ADDENDUM TO THE CONTRACT

JNU FIRE ALARM UPGRADE Contract No. BE21-159

ADDENDUM NO.: TWO

DATE ADDENDUM ISSUED: March 3, 2021

CONFORMED DOCUMENTS
SHEET NO.
E-1B411

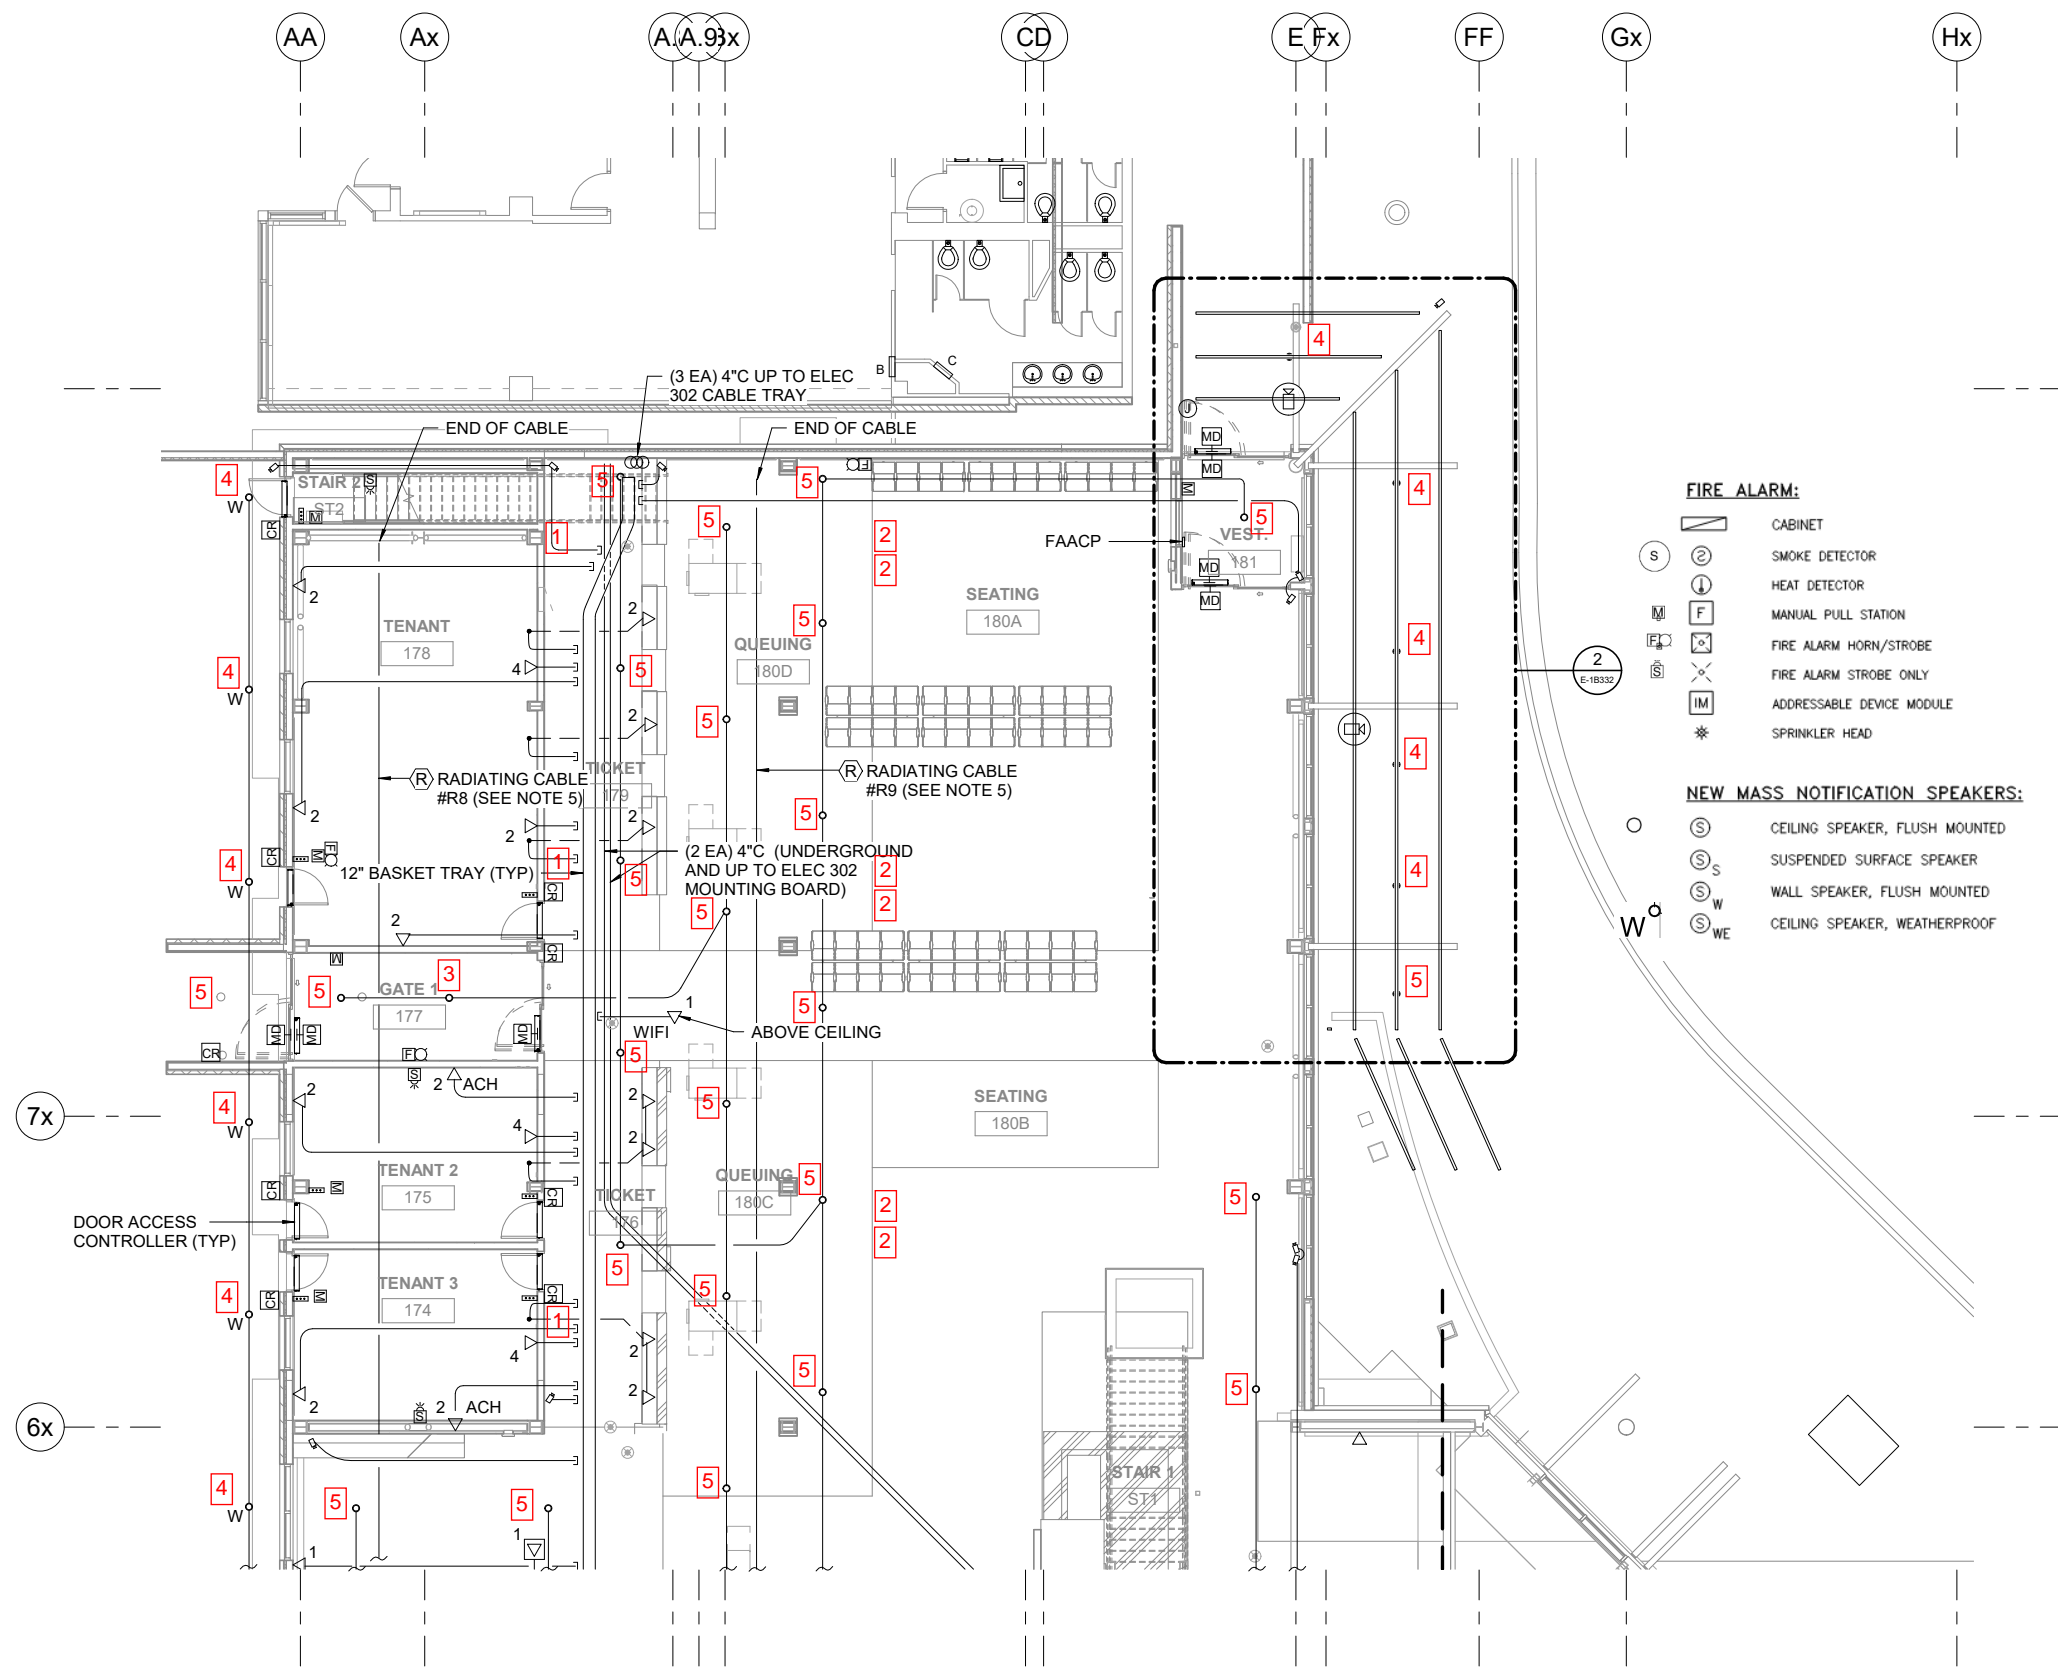
1. Furnish and install a wall mounted four square electrical box flush to the sheet-rock with a 3/4" conduit that terminates horizontally in an accessible ceiling oriented towards the nearest cable tray. Box to be 7" AFF.

2. Furnish and install a soffit mounted four square electrical box flush to the sheet-rock with a 3/4" conduit that terminates horizontally in an accessible ceiling oriented towards the nearest cable tray. Box to be centered vertically on the soffit.

3. Delete PA speaker from the project scope. In its place, furnish and install a ceiling mounted four square electrical box in its place flush to the sheet-rock with a 3/4" conduit that terminates horizontally in an accessible ceiling oriented towards the nearest cable tray.

4. Delete exterior PA speaker from the project scope. Furnish and install an exterior junction box and retain the PA conduit network to access an interior cable tray.

5. Delete PA speaker, wiring and electrical box from project scope.
6. Furnish and install a ceiling mounted four square electrical box flush to the sheet-rock with a 3/4" conduit that terminates horizontally in an accessible ceiling oriented towards the nearest cable tray.

SHEET NO.
E-1B412

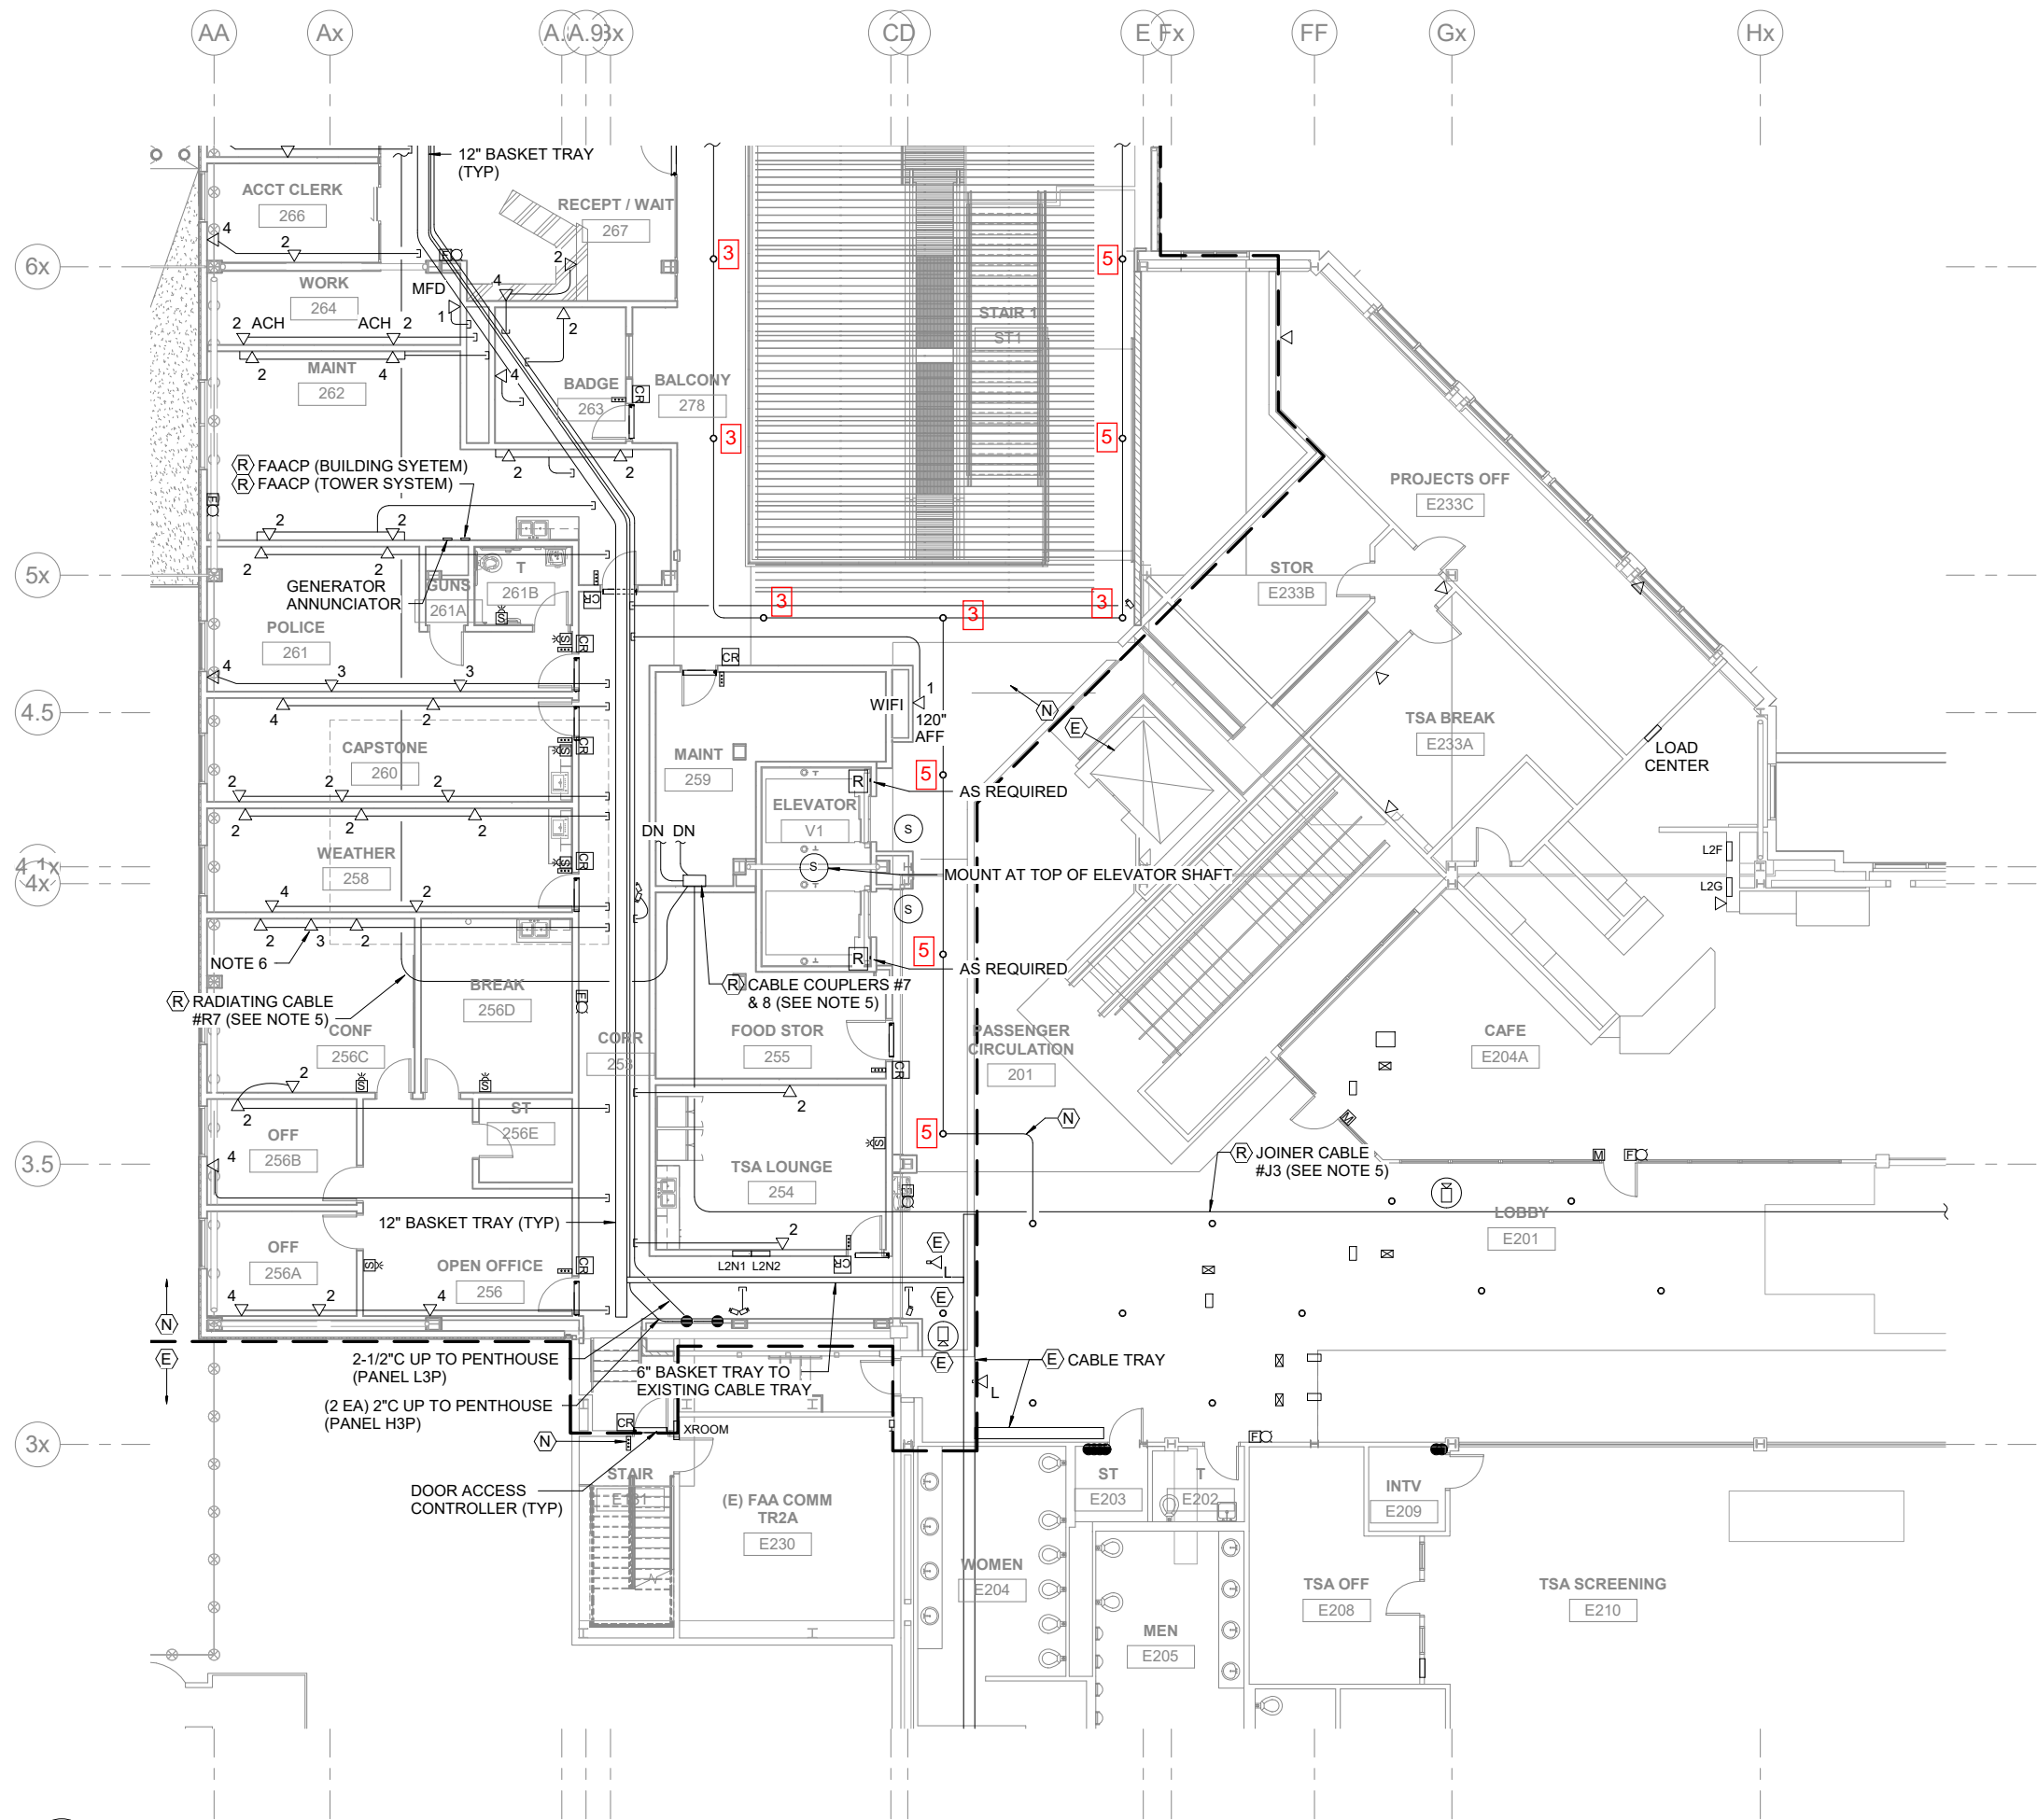
1. Furnish and install a wall mounted four square electrical box flush to the sheet-rock with a 3/4" conduit that terminates horizontally in an accessible ceiling oriented towards the nearest cable tray. Box to be 7' AFF.

2. Furnish and install a soffit mounted four square electrical box flush to the sheet-rock with a 3/4" conduit that terminates horizontally in an accessible ceiling oriented towards the nearest cable tray. Box to be centered vertically on the soffit.

3. Delete PA speaker from the project scope. In its place, furnish and install a ceiling mounted four square electrical box in its place flush to the sheet-rock with a 3/4" conduit that terminates horizontally in an accessible ceiling oriented towards the nearest cable tray.

4. Delete exterior PA speaker from the project scope. Furnish and install an exterior junction box and retain the PA conduit network to access an interior cable tray.

5. Delete PA speaker, wiring and electrical box from project scope.

SHEET NO.
E-1B421

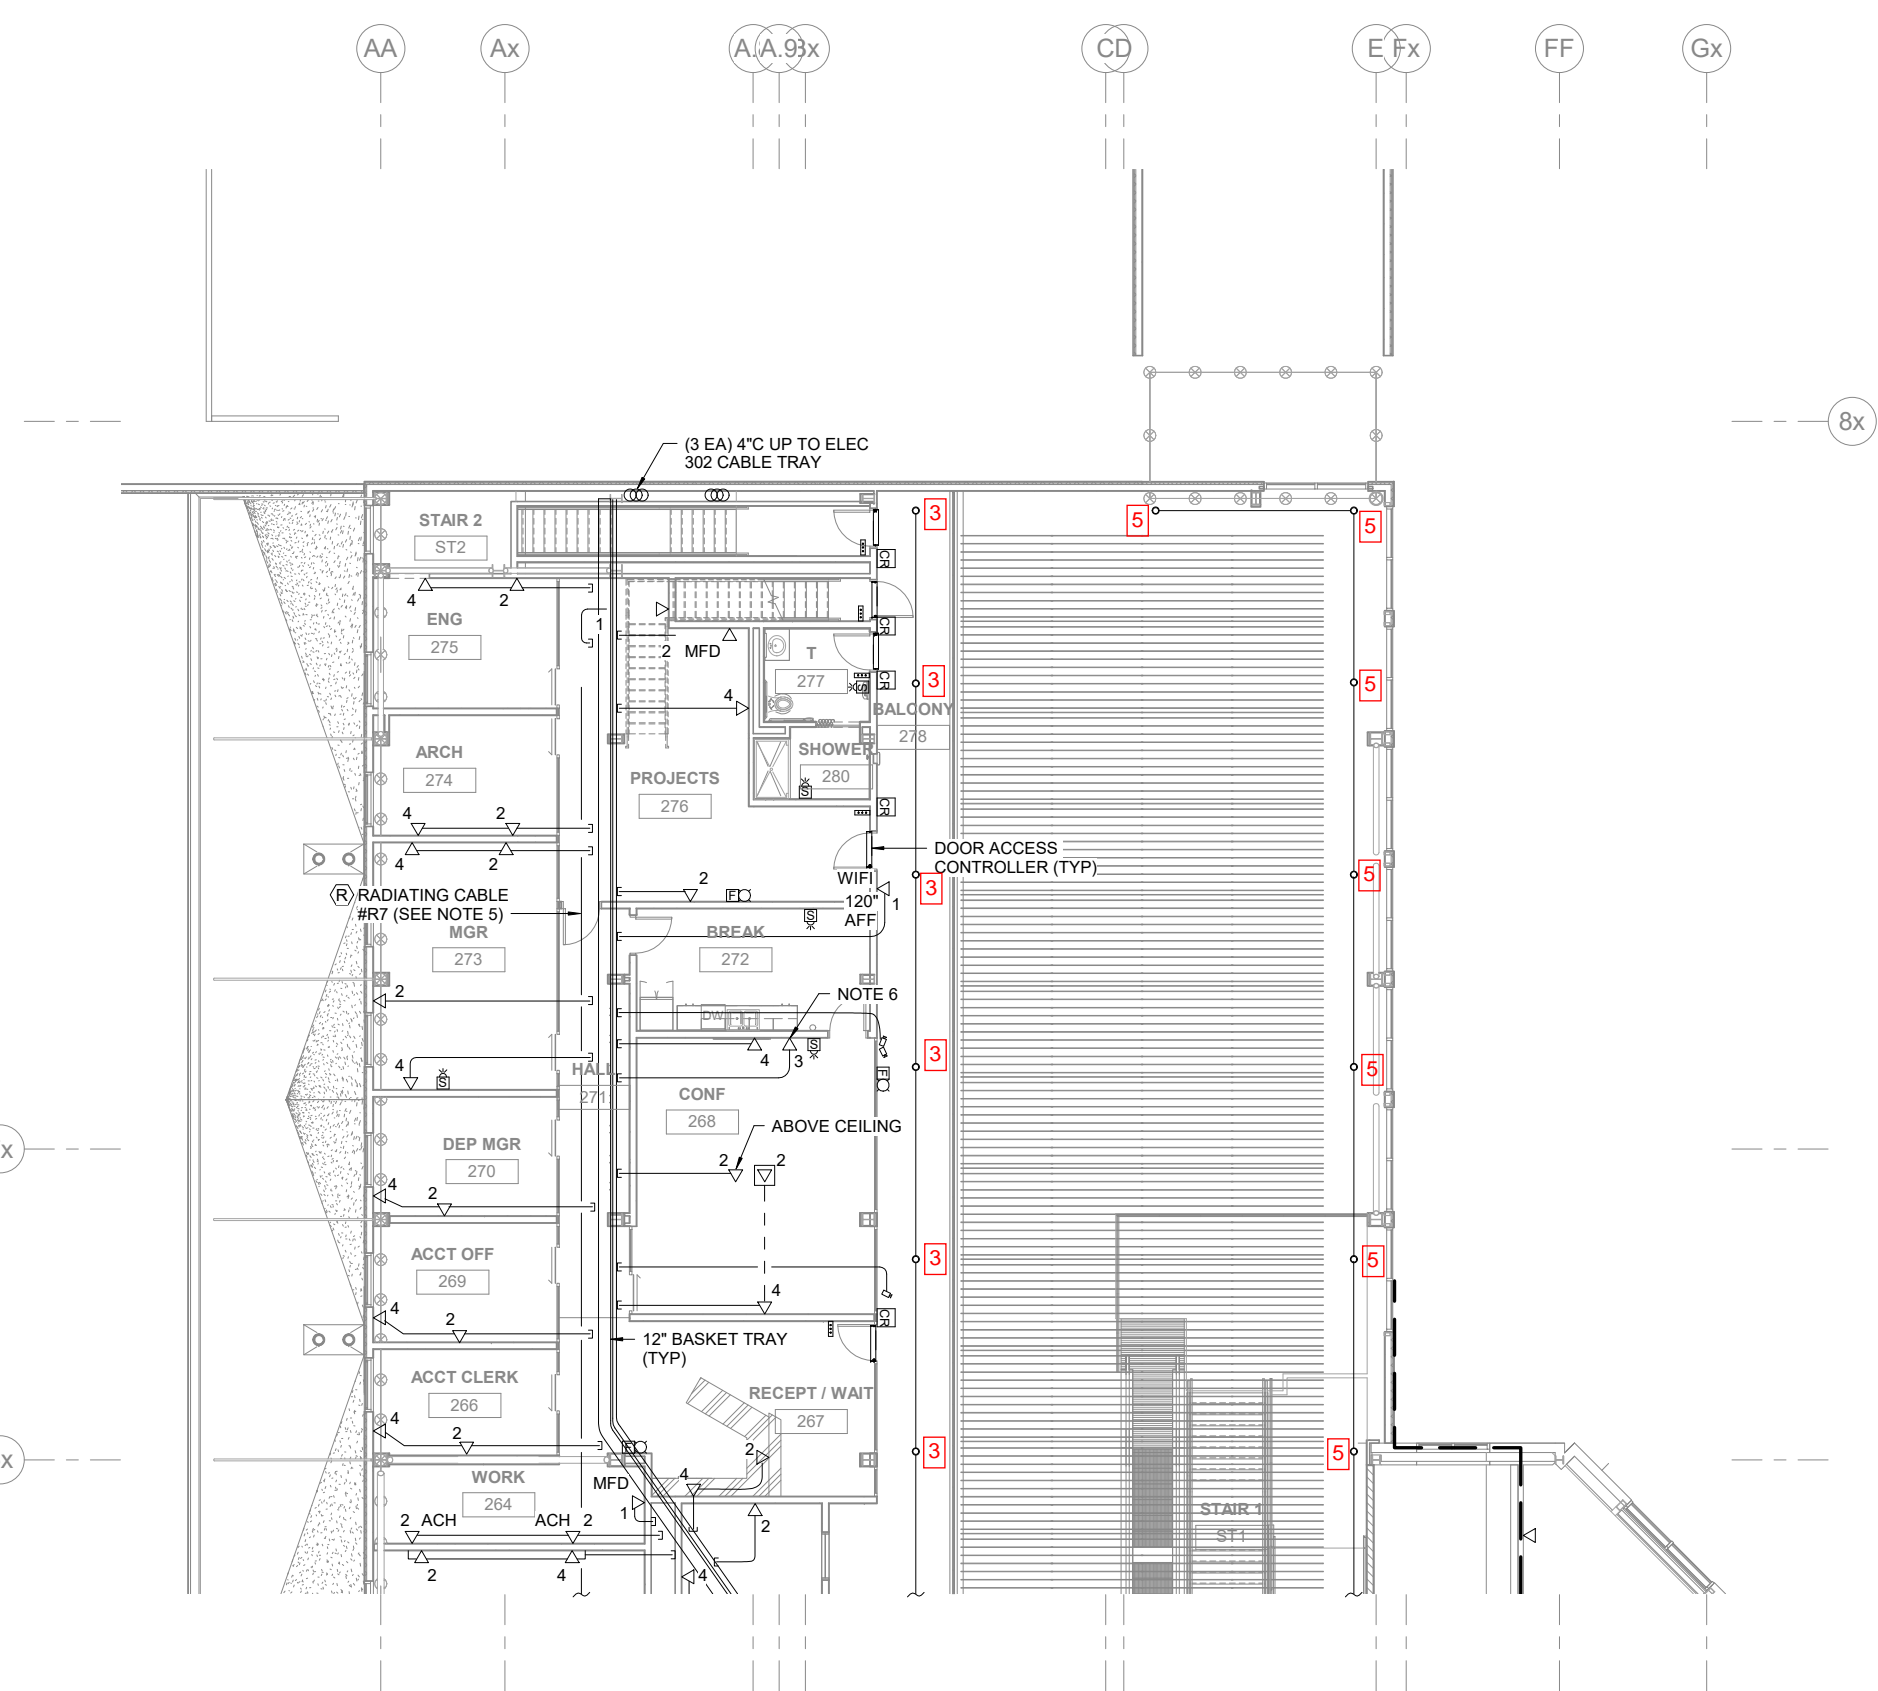
3. Delete PA speaker from the project scope. In its place, furnish and install a ceiling mounted four square electrical box in it's place flush to the sheet-rock with a 3/4" conduit that terminates horizontally in an accessible ceiling oriented towards the nearest cable tray.

5. Delete PA speaker, wiring and electrical box from project scope.
